ADDENDUM 2

RFP TDD 36-20

ARTIST(S) FOR STATUES AT VETERANS PARK ON OKALOOSA ISLAND

FIGURE 5
 PROJECT OVERVIEW
 OKALOOSA BAYWALK
 OKALOOSA COUNTY, FLORIDA

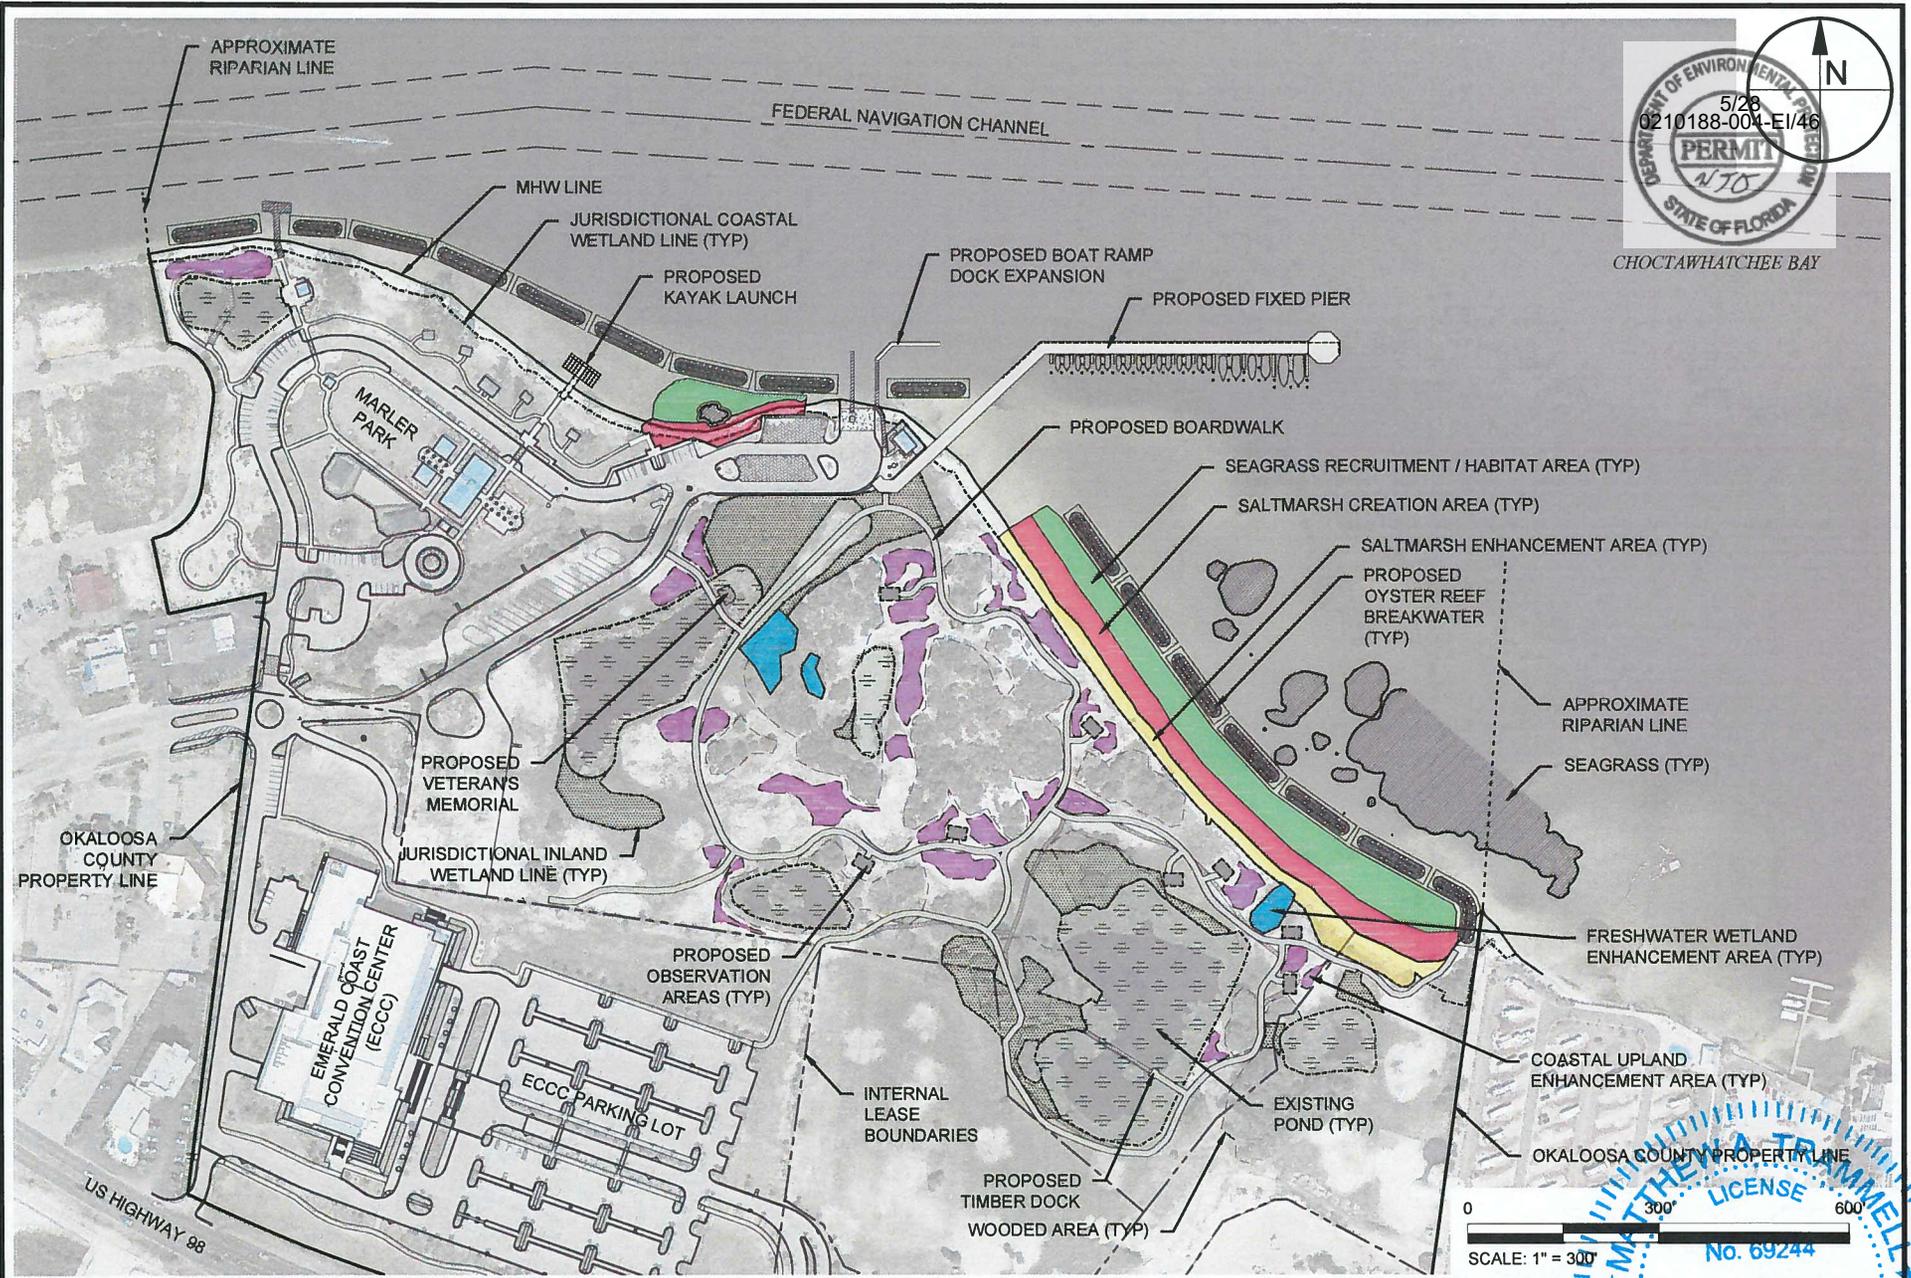
1. For the location of the site, can you please provide the approximate square footage, as well as an exact pin point location at Okaloosa Island in the Veterans Park? **See attached.**

2. Are there any plans, designs or photos of Veterans Park? **See attached.**
3. Can the sculpture design vary from eight individual statues? **TBD by selection committee.**
